Wetland Impacts West Essex Highlands

June 4, 2025

Mark Gallagher

Snapshot from
ACS plan sheet
SP-55 of Basin 7

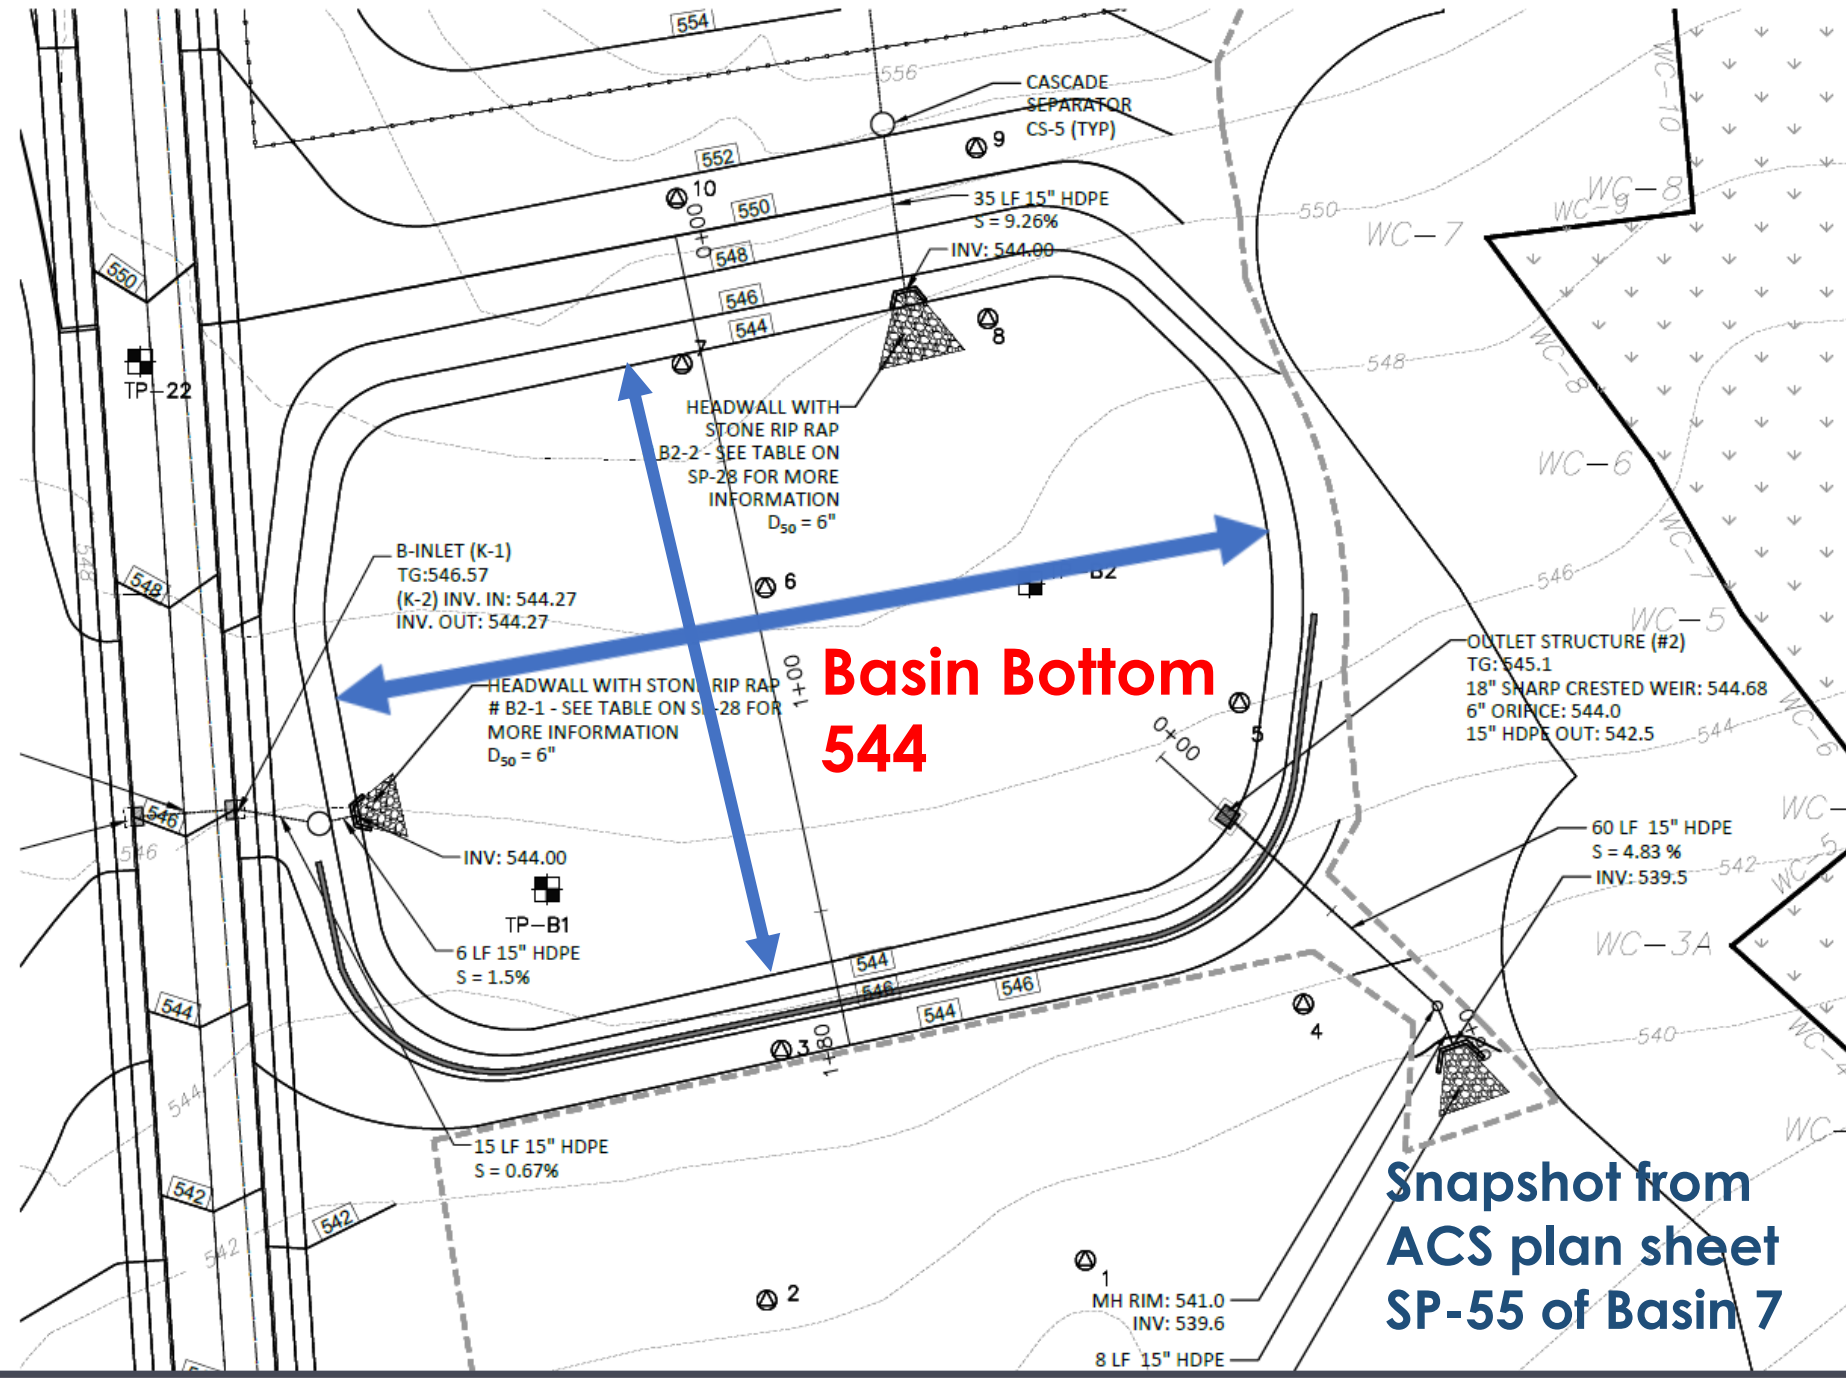
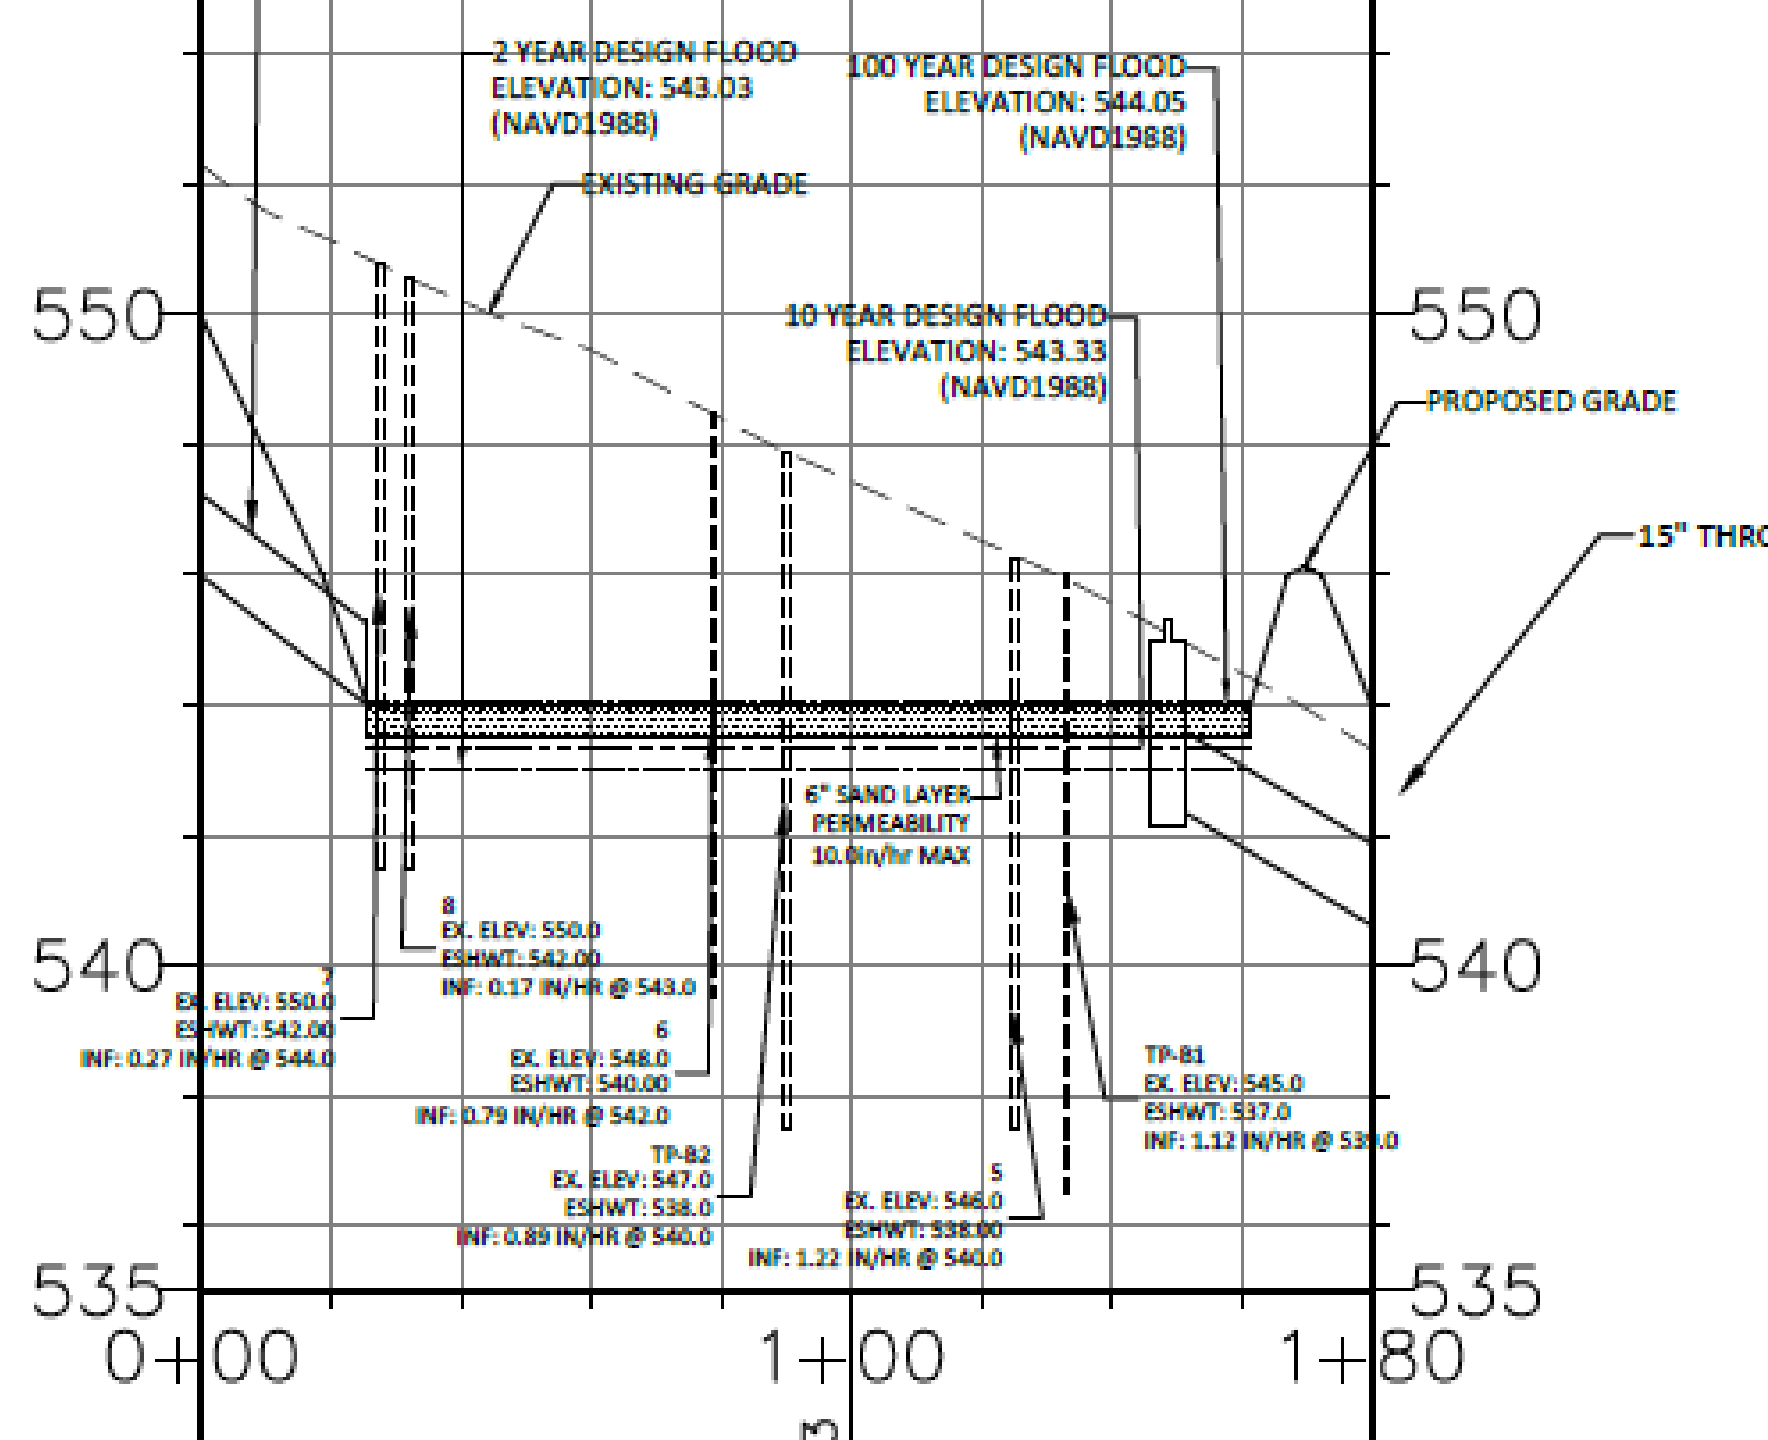
ESHWT 15 feet lower than
the adjacent wetland?
